# AGAINST SMITH - 2<sup>nd</sup> REPORT • WHY ACCEPTED OUT OF TERMS?? (1)

CASE NO. 1:16-cv-21199-CMA

**SUPPLEMENTAL EXPERT REPORT  
OF RICK A. SMITH, P.E.**

**Black Box (JM Products)**

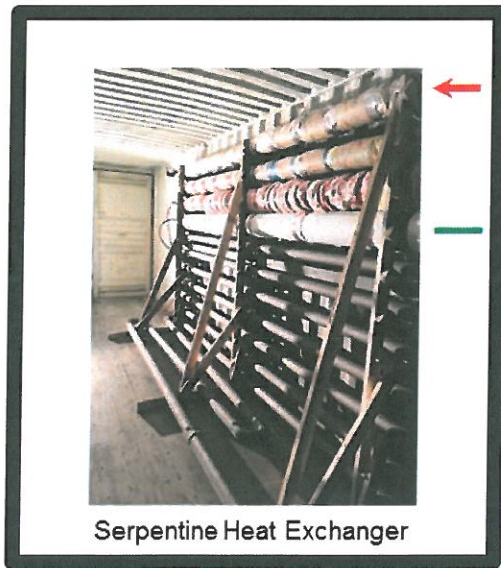
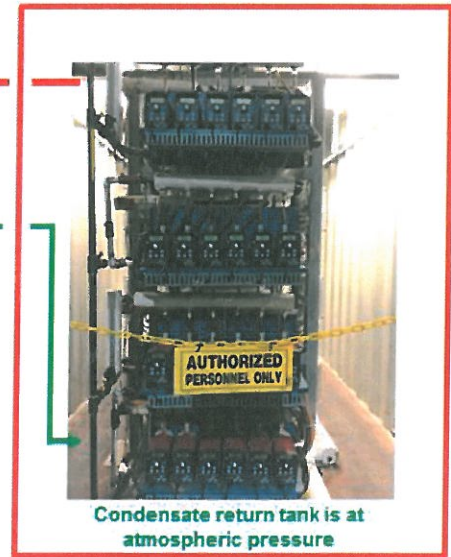
(2) p. 5 THE SCHEMATIC IS SIMPLY WRONG. SMITH DESIGNS A PLANT HE DOES NOT KNOW: NO EXPERT WITH PROFESSIONAL DIGNITY COULD EVER DO SO.

(3) p. 6: THERE WAS A RECIRCULATOR

(6) THE RECIRCULATOR EASED THE STEAM FLOW.  
AGAIN: SMITH TALKS OF A PLANT HE DOES NOT KNOW!

(7) WRONG: THE INTERNAL WATER TANK NEVER WAS DESIGNED TO LEAK INTO ATMOSPHERE! THEREFORE ALL THE FOLLOWING CONSIDERATIONS ARE GROUNDBLESS. BY THE WAY, HERE SMITH SAYS A TITANIC STUPIDITY: EVEN IF THE TANK WAS AT

ATMOSPHERIC P, IT CONTAINED WATER THAT WAS ENVOYED TO THE REACTORS, AND IT WAS THERE THAT THE WATER BECAME STEAM! AGAIN, SMITH TALKS OF THINGS HE DOES NOT KNOW. (2)

Picture taken from street on 03 Nov 2015.

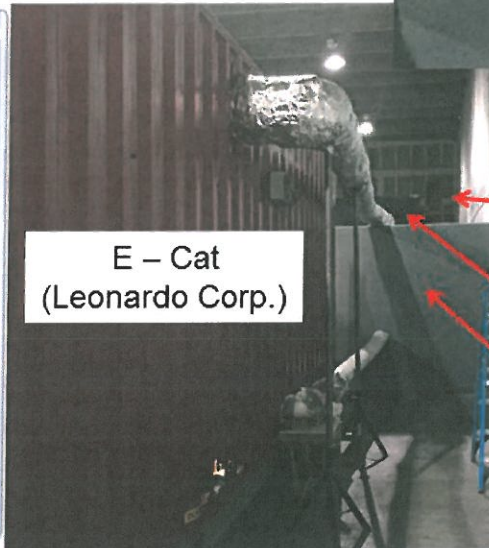
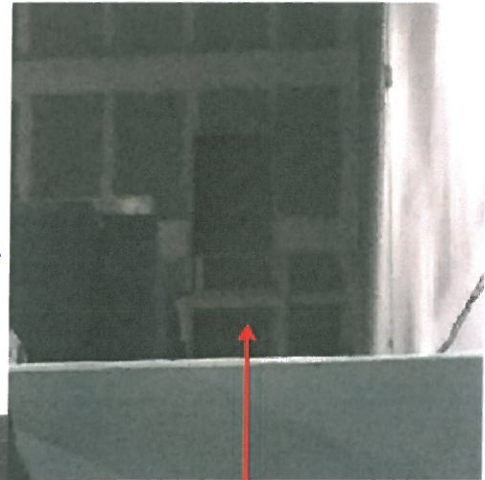
(10) p. 9 : PHOTO: SO, WHAT? FROM THIS PHOTO IS EVIDENT THAT AIR PASSED THROUGH THE LEFT HALF OF THE CENTRAL WINDOW. BY THE WAY: ALL WINDOWS WERE EASILY OPERABLE IN ALL SECTIONS AND WE MANY TIMES CHANGED CONFIGURATION.

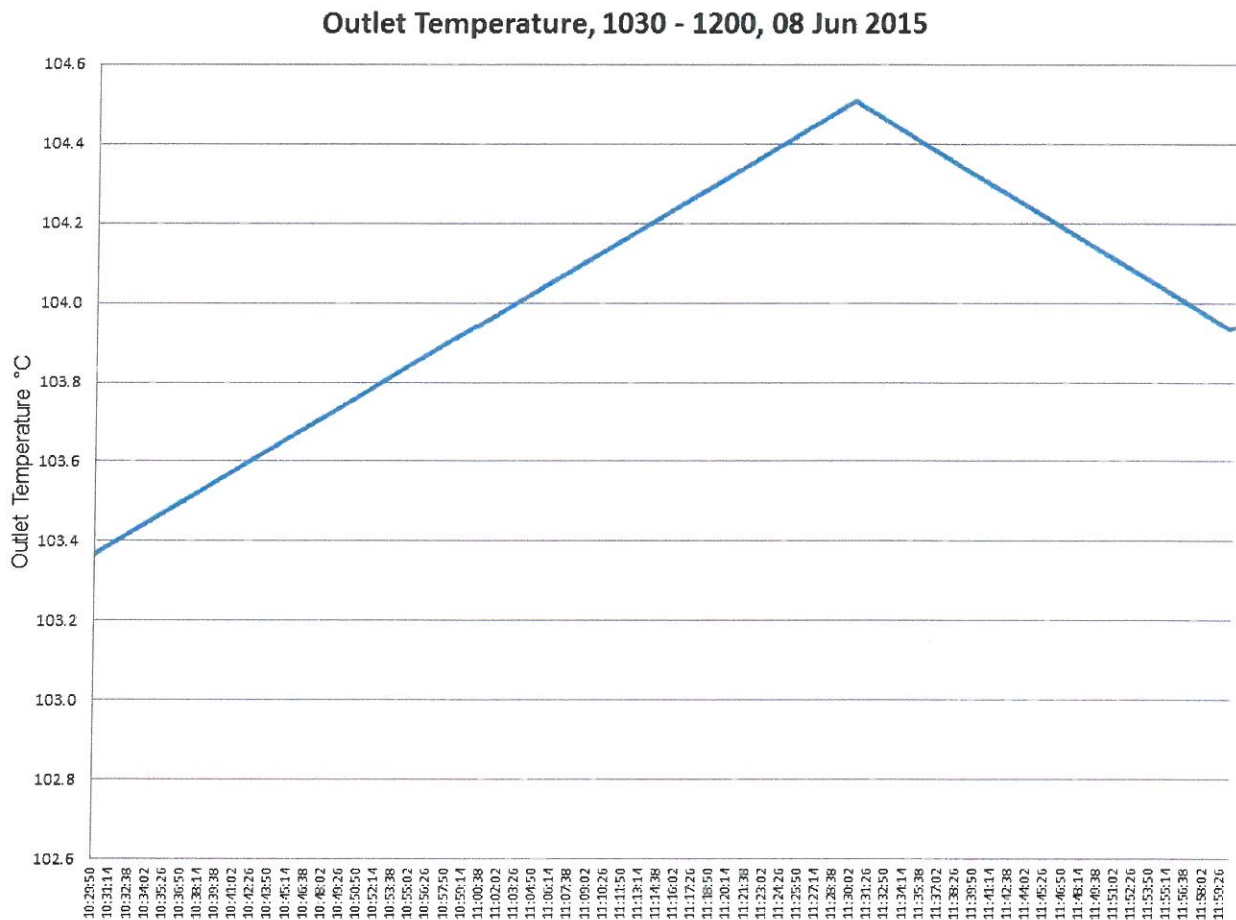
-15-14-15  
(14) - pag. 12: FABIAW'S DATA:

TOTALLY STRANGE TO US AND TO THE AGREEMENT. I DIDN'T EVEN KNOW THAT FABIAW WAS TAKING DATA - IF HE DID ON BEHALF OF IH, THIS IS FURTHER EVIDENCE OF HIS DEPENDENCY FROM IH, INDEPENDENCE FROM ME. WHATEVER THE DATA WERE, I AM NOT AWARE OR RESPONSIBLE OF THEM, WRONG OR RIGHT AS THEY MIGHT BE.

Close up of the name plate of an individual feed pump. Dosierleistung is translated as dosing capacity or maximum flow.

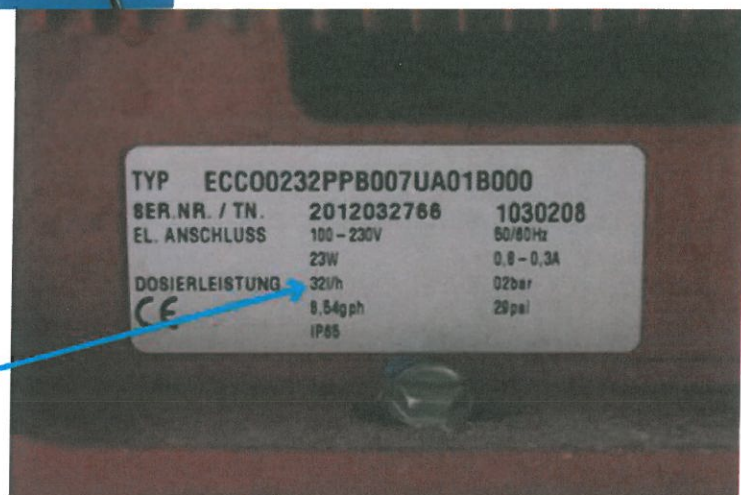
(15) pag. 16-17.

HERE WE ARE AT THE TRAGICOMIC ASPECT OF THE "EXPERTISE" MADE BY THE "EXPERT":

HE WRITES 2 PAGES OF STUPIDITIES CONSEQUENTIAL TO THE "FACT" THAT HE READS ON THE PHOTO OF THE LABEL "MAX OUTPUT IS 32 LITERS PER HOUR".

BUT HE (EITHER VOLUNTARILY OR FOR INEXPERTISE) DID NOT READ THAT ~~SEE~~ AT THE RIGHT SIDE OF THE "32 L/H" SCRIPT IS WRITTEN "02 BAR"!

EVERY REAL EXPERT OF THE ART WOULD HAVE KNOWN THAT THE AMOUNT OF LITERS PER HOUR IS NOT A NUMBER, BUT AN INTEGRAL WHEREIN THE LPH ARE IN FUNCTION OF THE PRESSURE THAT THE PUMP HAS TO WIN TO PUSH THE WATER THROUGH.

IN FACT, CORRECTLY THE MANUFACTURER INFORMS IN THE LABEL THAT THE PUMP IS ABLE TO PUSH 36 LPH AT A PRESSURE OF 2 BARS, WHEREIN 2 BARS CORRESPOND TO PUSH THE WATER UP TO A HEIGHT OF 20 meters.

BUT IN OUR CASE THE PUMPS HAVE TO PUSH THE WATER TO A HEIGHT THAT AVERAGES 1 meter, which CORRESPONDS TO  $\frac{1}{10}$  OF BAR !!!

WITH A SO LOWER PRESSURE TO WIN, THE CAPACITY OF THE PUMP RAISE IN PROPORTION.

BUT HERE WE HAVE ALSO ANOTHER EXAMPLE OF THE LACK OF PROFESSIONALITY OF MR. SMITH: THERE WAS NOT ONLY THE PUMP SYSTEM TO PUSH THE WATER, BUT ALSO THE RECIRCULATOR, SO THAT THE PUMPS CHARGED WATER FROM ONE SIDE, WHILE THE RECIRCULATOR PUSHED WATER FROM THE OPPOSITE SIDE.

# Conventional Steam System

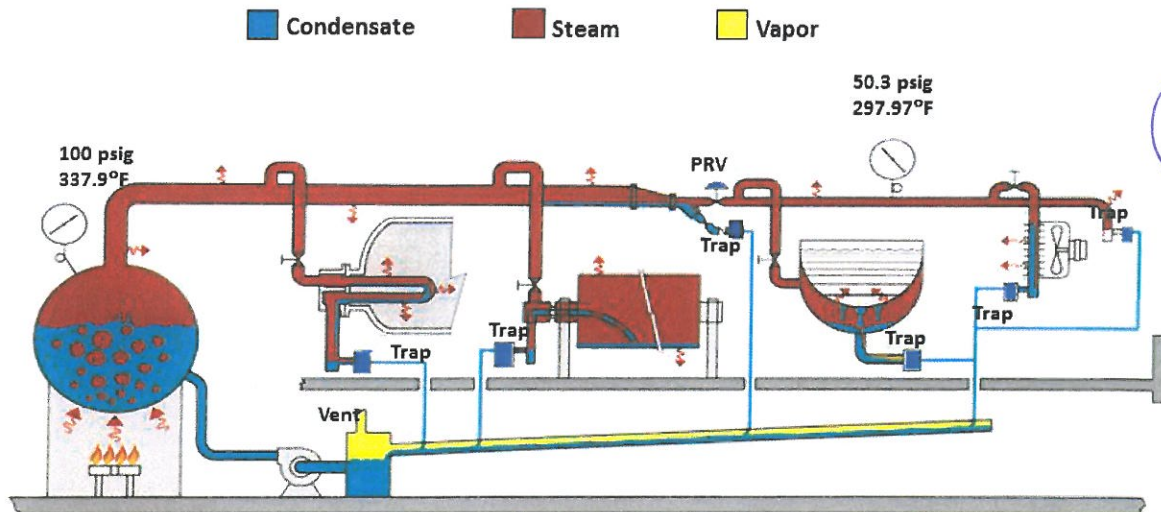
P. 21 - (17) + PAGE 22

HERE MR. SMITH SHOWS A CONVENTIONAL STEAM SYSTEM, WHICH IS HIS TURF, AND WHICH HAS NOTHING TO DO WITH OUR ECAT.

TO COMPARE A CONVENTIONAL STEAM BOILER TO THE E-CAT IS LIKE TO COMPARE A TRUCK TO AN AEROPLANE. ALL THE DEDUCTIONS OF MR SMITH IN PP ~~20~~ 21-22 ARE GROUNDFLESS, BECAUSE THE E-CAT SYSTEM HAS NOTHING TO DO WITH A REGULAR STEAMER.
